DONCASTER BEVERLY DANBURY RECONSTRUCTION

ASSESSMENT DISTRICT - 2024

CITY PROJECT NO. 14079
CONTRACT NO. 8709

REVISION #1- 8/15/2024
REVISED THE FOLLOWING:
EC4, EC6, G11, G13-G15, PD2-PD6, P2-P6, U4-U5, W1, X4-X5, X7, X9, X12

14079
PD-5

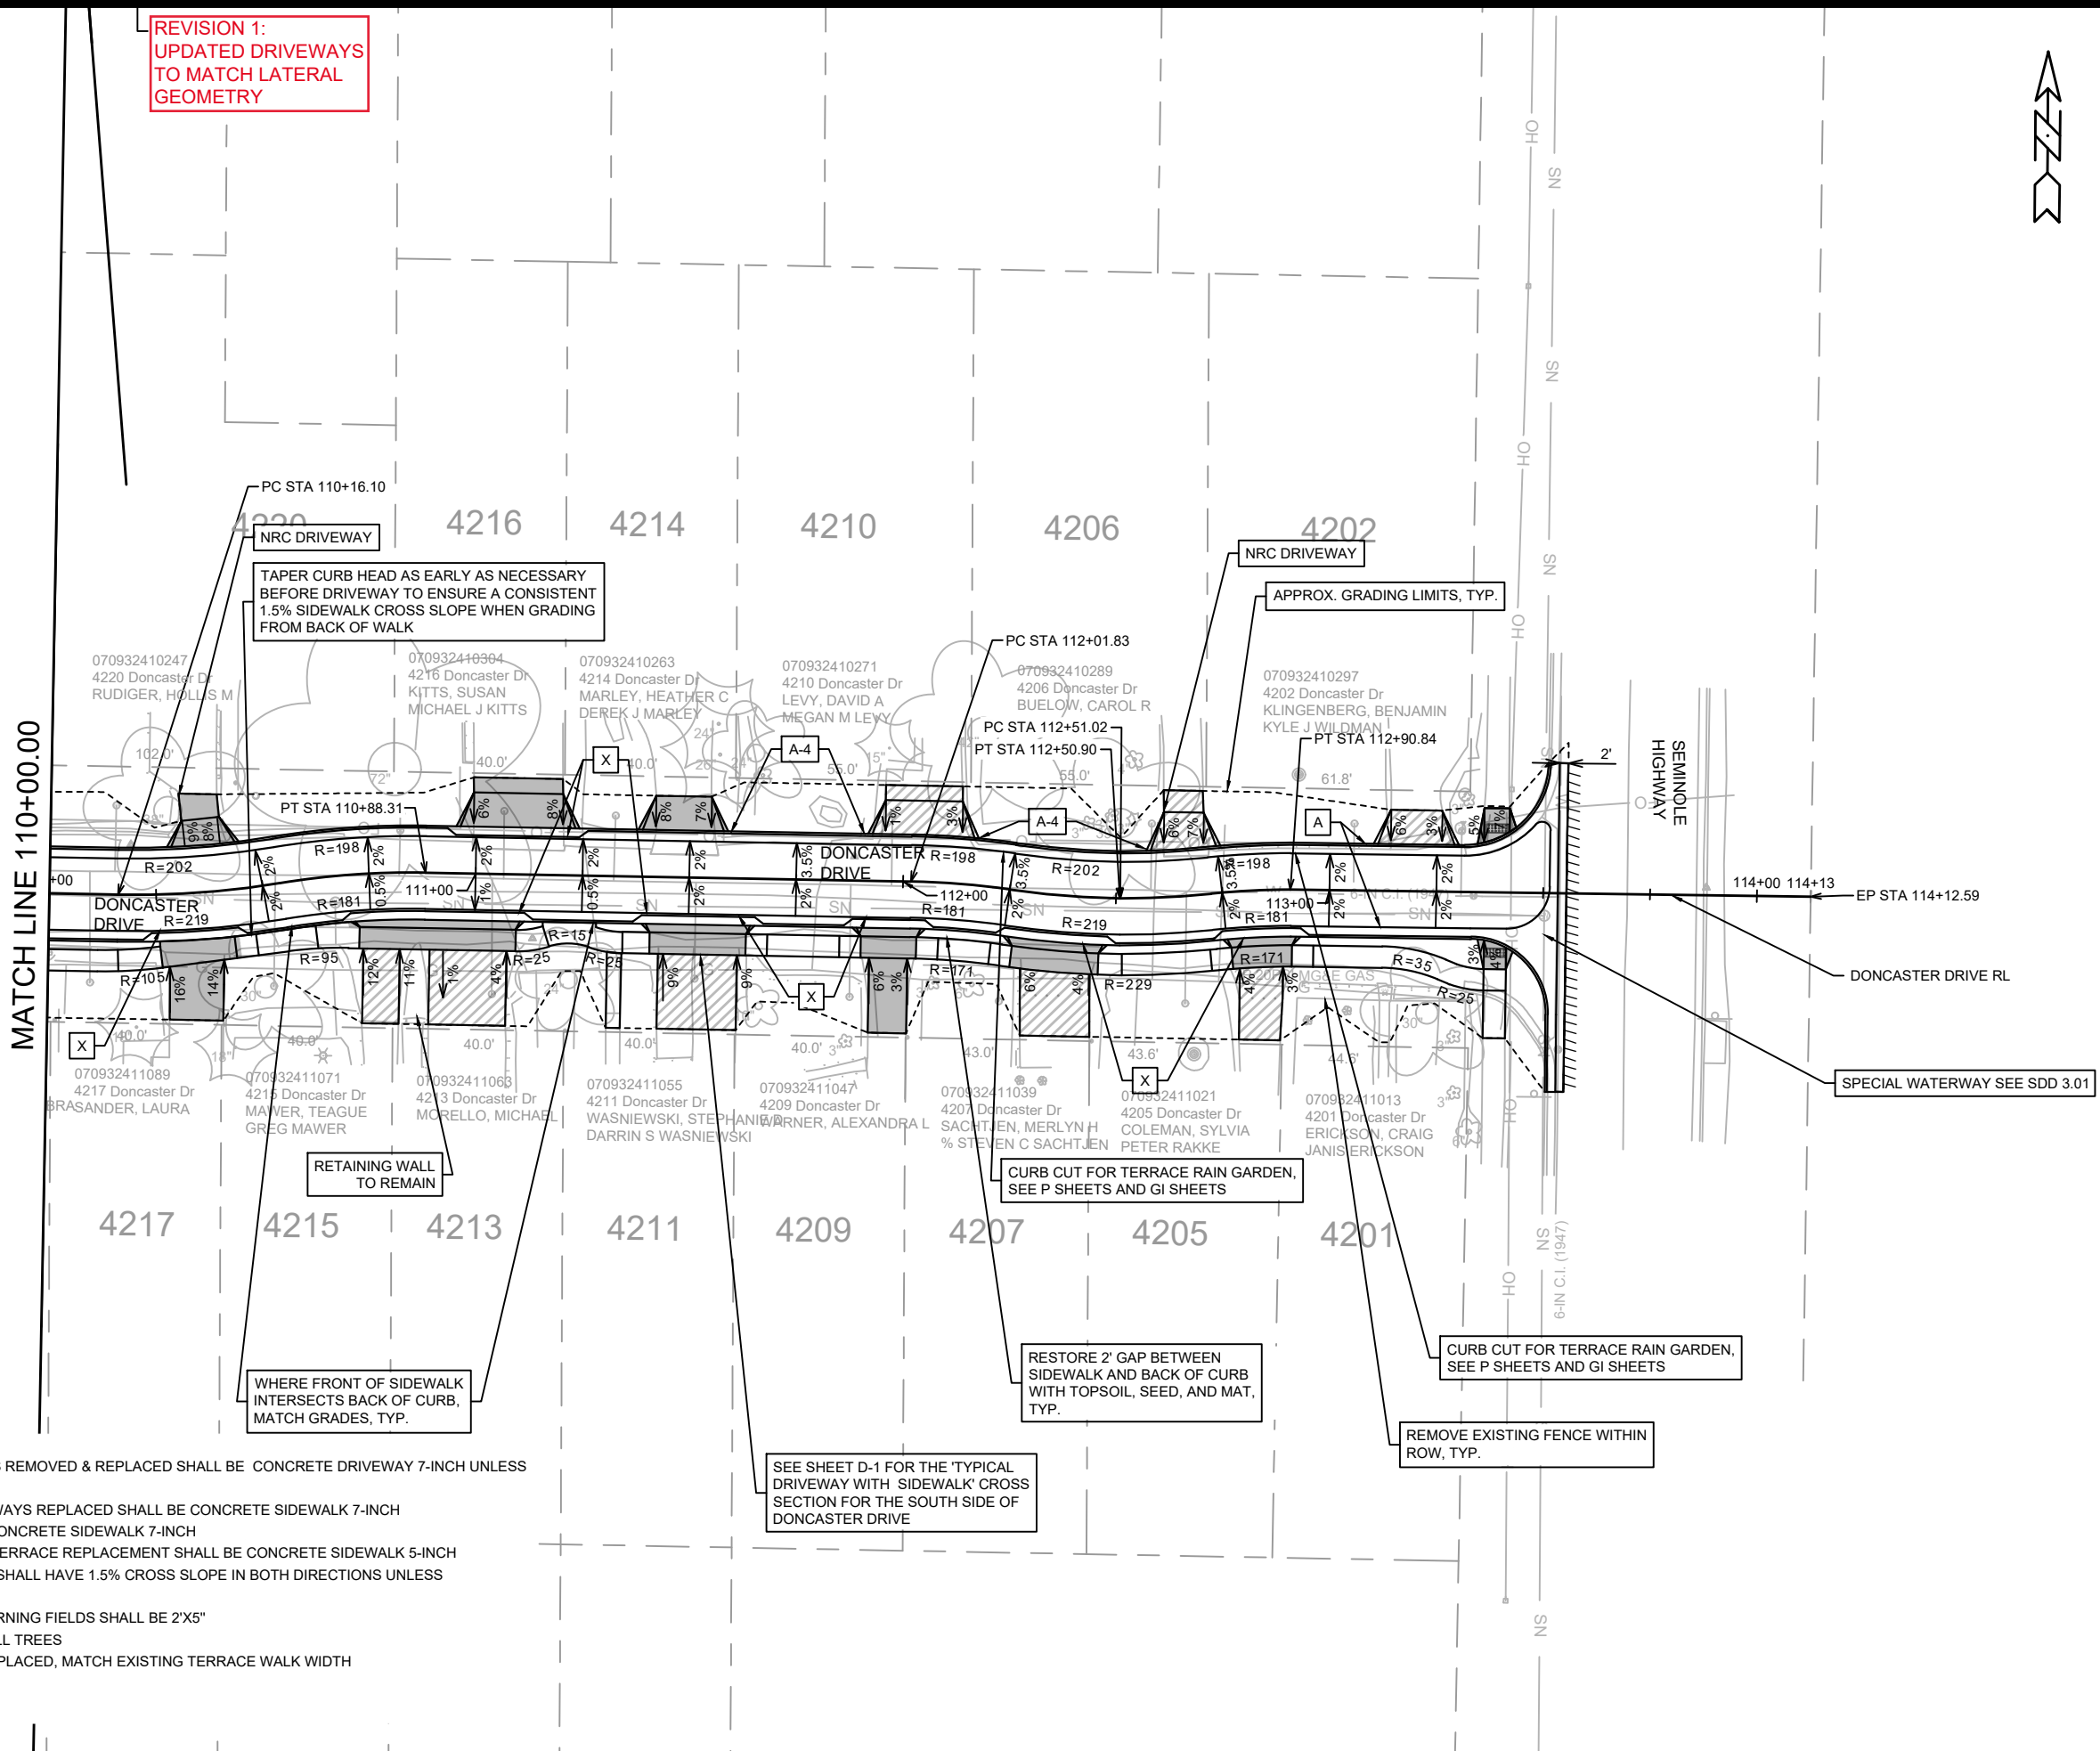
REVISION 1:
UPDATED DRIVEWAYS
TO MATCH LATERAL
GEOMETRY

14079
PD-6

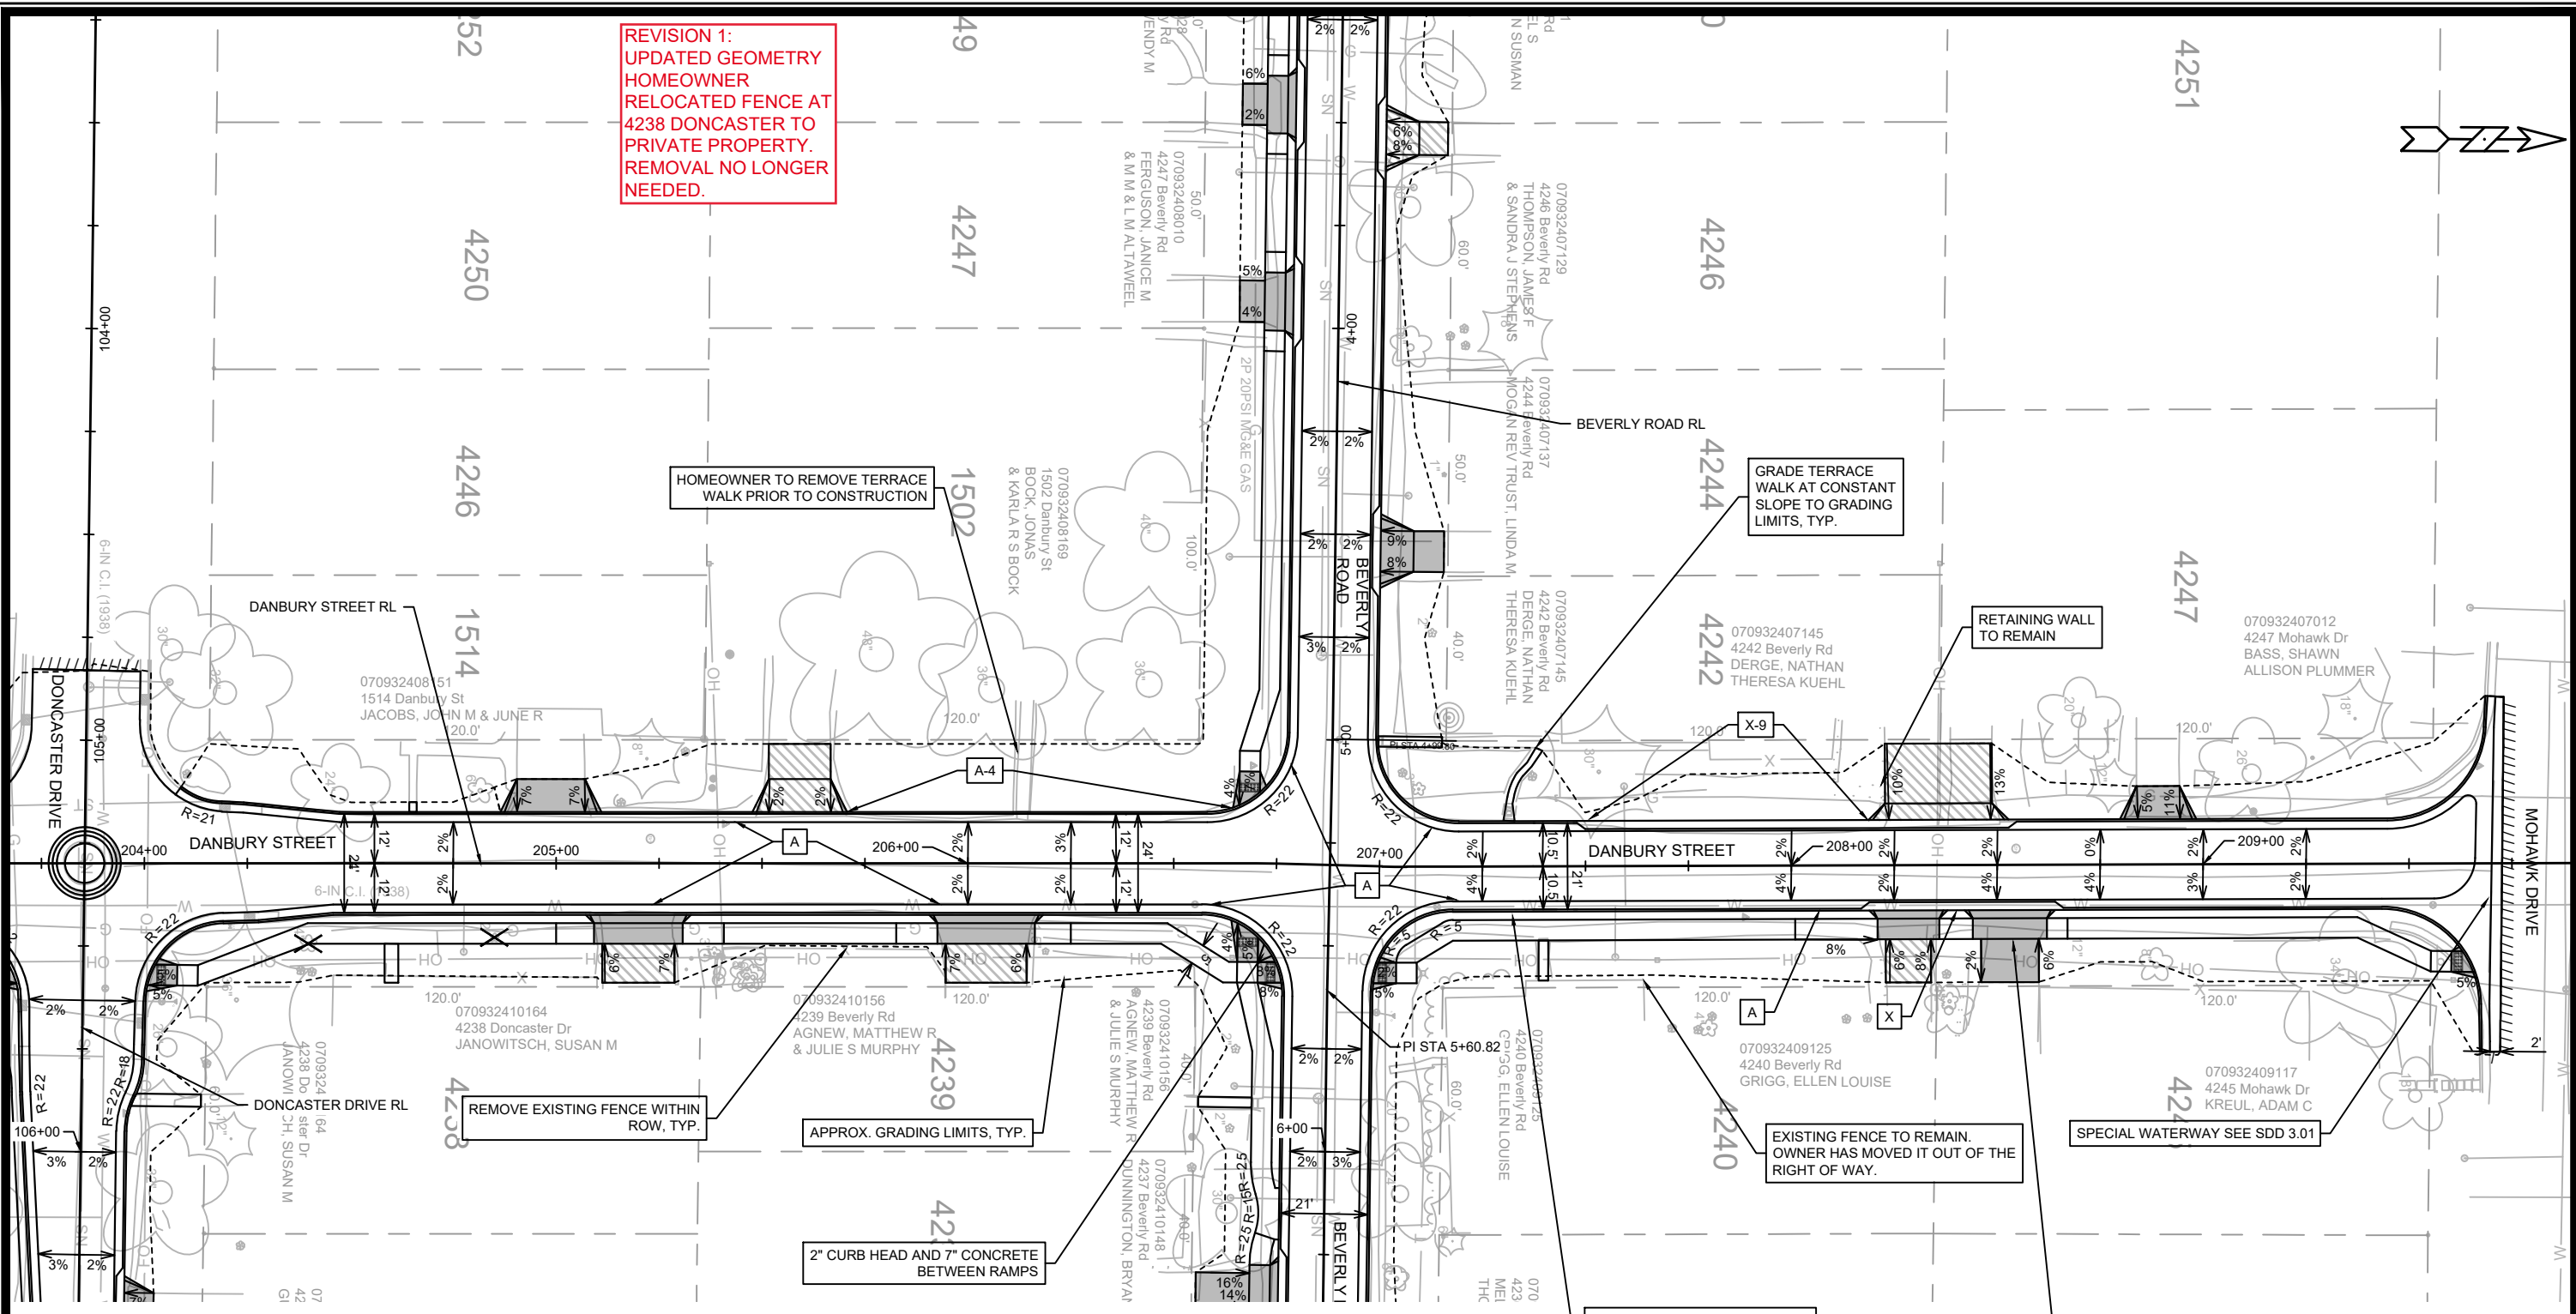
**REVISION 1:
UPDATED GEOMETRY
HOMEOWNER
RELOCATED FENCE AT
4238 DONCASTER TO
PRIVATE PROPERTY.
REMOVAL NO LONGER
NEEDED.**

BEVERLY ROAD PLAN & PROFILE
DONCASTER BEVERLY DANBURY RECONSTRUCTION
M:\DESIGN\Projects\14079\CAD\Streets\14079EN-PnP.dwg

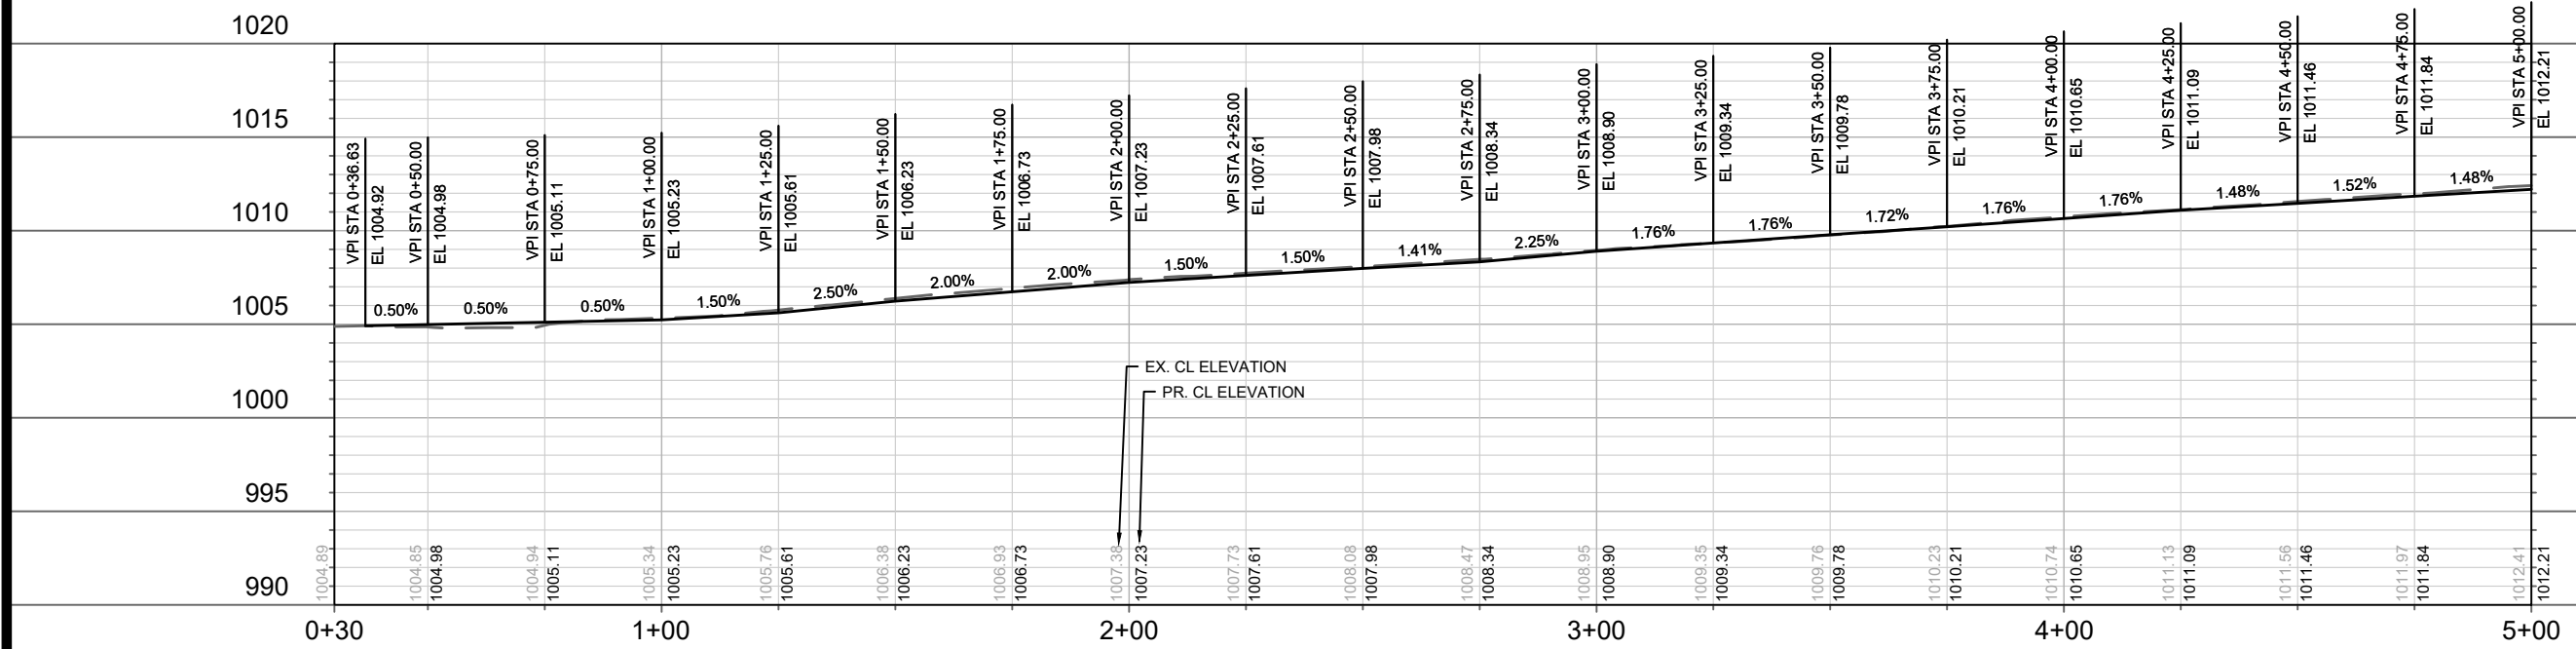
ADDENDUM NOTE:
REMOVED RAIN GARDEN
AT 4254 BEVERLY RD
